**U.S. DEPARTMENT OF ENERGY (DOE) RESPONSE TO U.S. NUCLEAR  
REGULATORY COMMISSION (NRC) REQUEST FOR ADDITIONAL  
INFORMATION ON THE DOE TOPICAL REPORT ON DISPOSAL CRITICALITY  
ANALYSIS METHODOLOGY**

The NRC provided DOE with a Request for Additional Information (RAI) on our Disposal Criticality Analysis Methodology Topical Report (YMP/TR-004Q). We appreciate the NRC's detailed review that resulted in the RAI (reference).

Figure 3.6-1 In-Drift Saturation Profile (0.5 mm sand, episodic flood)

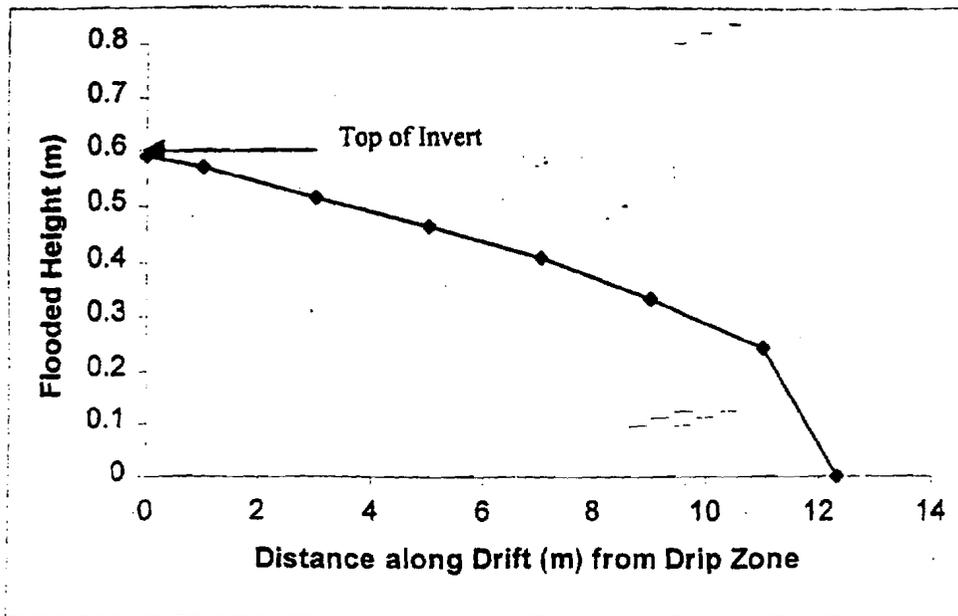
RAI 3-6        *Clarify whether credit will be taken in the criticality analyses for the assumption that there is no mechanism for completely sealing the fractures in the bottom of the drift so any in-drift accumulations of water will only be present for a few weeks.*

*Previous investigations have indicated that thermal alteration of the rock surrounding the repository or microbial growth has the potential to seal fractures, at least in local portions of the repository (Lin and Daily, 1989<sup>1</sup>). Although it appears that the scenarios listed in figure 3-2 include the potential for water to pond on the bottom of the drift, if credit is taken for the short duration of*

Based on the current work summarized below, DOE expects to be able to show that ponding in the drift to a depth of more than a few centimeters is highly unlikely. DOE is presently investigating the possible mechanisms for plugging the fractures (deposition of minerals, clay buildup, and deposits from microbial growth); all indications thus far are that they would be very unlikely to fill all the fracture openings in the drift floor beneath the waste package. In the meantime DOE has performed a simple conservative analysis of the maximum depth that could be sustained under the worst-case (highly unlikely)

The profile of the water height as a function of the distance along the drift axis is shown in Figure 3.6-1.

Figure 1-1. Overview of Disposal Criticality Analysis Methodology

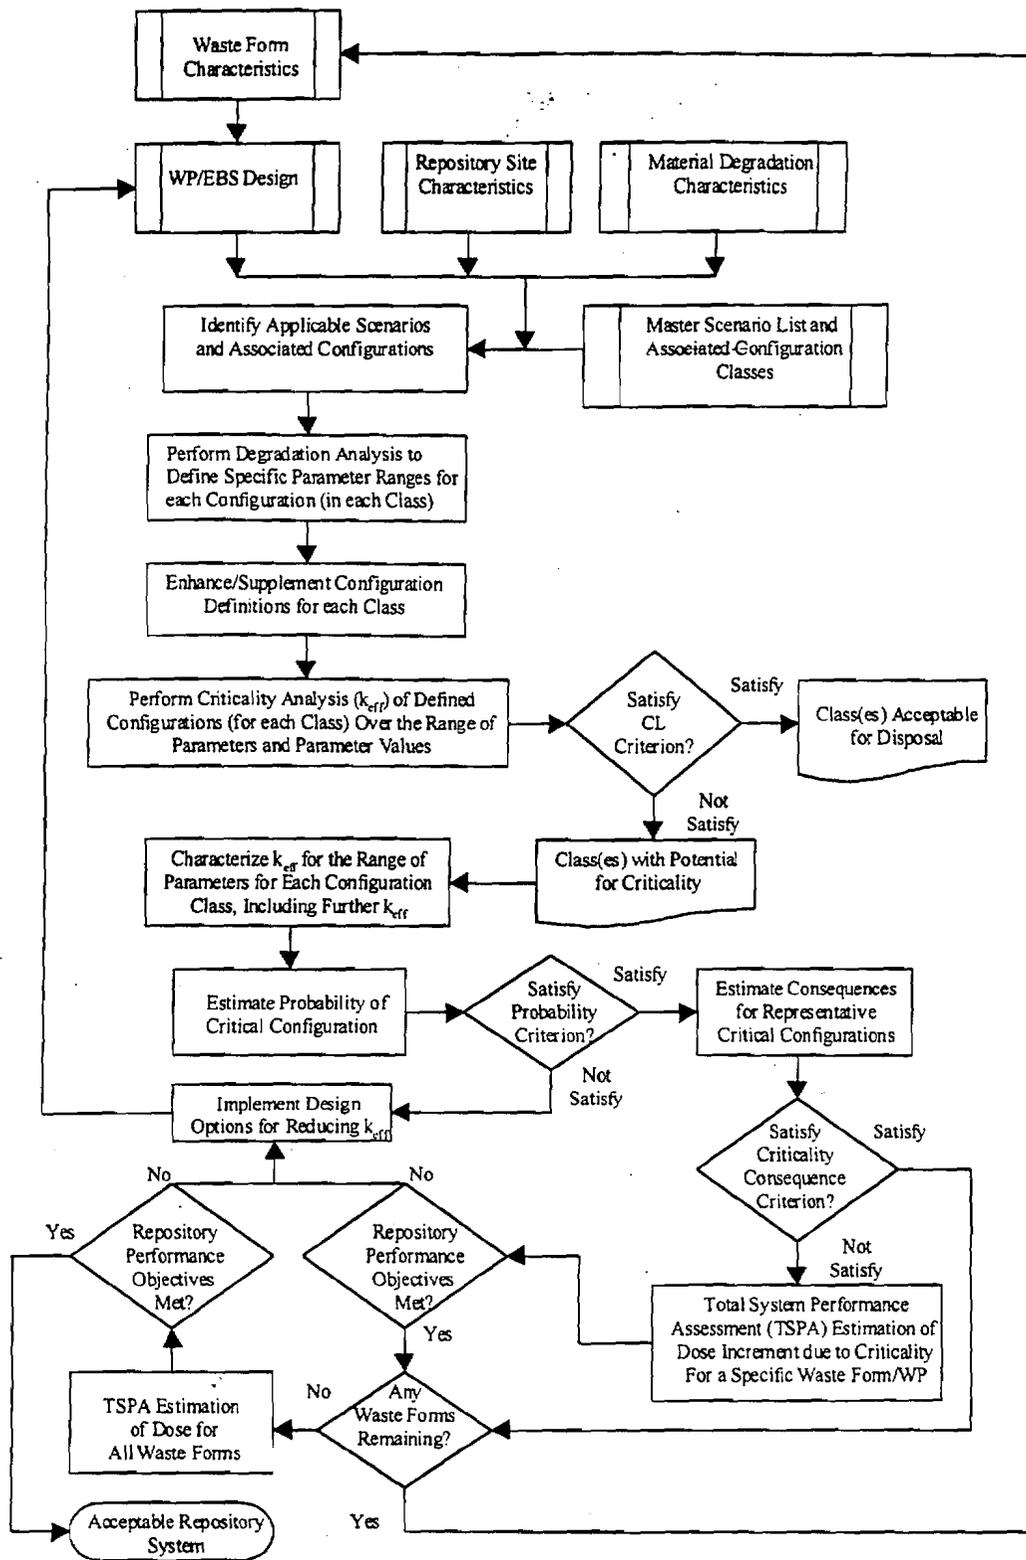
*RAI 1-8 Justify the approach used to dismiss configuration classes as having the potential for criticality based on an evaluation of a given configuration with parameter values at some selected points for each of the configurations (Figure 1-1).*

The criticality consequence criterion refers to a single criticality to provide a screening criterion for individual waste forms. This is a coarse criterion intended to identify those design/waste form combinations that can immediately be characterized as requiring a detailed Total System Performance Assessment (TSPA) evaluation. It is expected that most design/waste form combinations will pass this screening. However, criticality consequences may subsequently be identified with an unacceptably large contribution to the overall dose at the accessible environment (the ultimate consequence, determined by the TSPA). DOE plans to add this feed of all criticality consequence results to the overall TSPA to the Overview (Figure 1-1) when the Topical Report is revised. Attachment B shows an updated version of the overview figure.

Figure 1-1 requires that configurations be evaluated "for a range of parameters and parameter values." This is from the box above the "satisfy Critical Limit (CL) criterion" decision diamond. The intent of the box above the first decision point in Figure 1-1 is to evaluate the full range of parameter values to prevent a potentially critical configuration from being overlooked. In practice this may include examining only bounding values for certain key parameters and the range of values for other parameters. For example, a configuration class of intact commercial fuel in a waste package may be evaluated with 5 wt% U-235 fuel. If the case satisfied the CL criterion, there would be no need to run the same configuration with 4 wt% U-235 fuel and the same or greater burnup. But if the CL criterion was not satisfied, the configuration class would be considered potentially critical, and additional cases would be run to develop regression expressions (the second box to the right of the satisfy CL criterion decision diamond). The justification for acceptance of a specific configuration is considered an application issue and not a methodology issue. Therefore, the justification will be provided in the supporting documents for the License Application to allow NRC review and concurrence.

The referenced box in Figure 1-1 will be modified as follows:
